TECH TALK

NAPA 100025

OE OX 813/1
BMW 11428575211

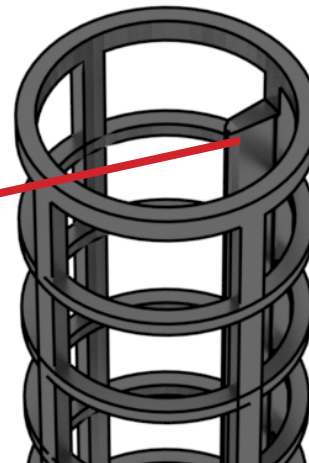
The NAPA 100025 is not a suitable replacement filter for applications requiring the OE filter OX 813/1 (BMW 11428575211). The OX 813/1 has an alignment tab inside of the filter center tube. The tab fits into a slot in the oil housing ensuring proper alignment during filter installation. The NAPA 100025 does not have the alignment tab and can be installed incorrectly resulting in low oil pressure during vehicle operation.

Filter Housing

Center Tube Align Tab

The correct NAPA replacement filter for the OE OX813/1 (BMW 11428575211) is the soon to be available NAPA 100358.
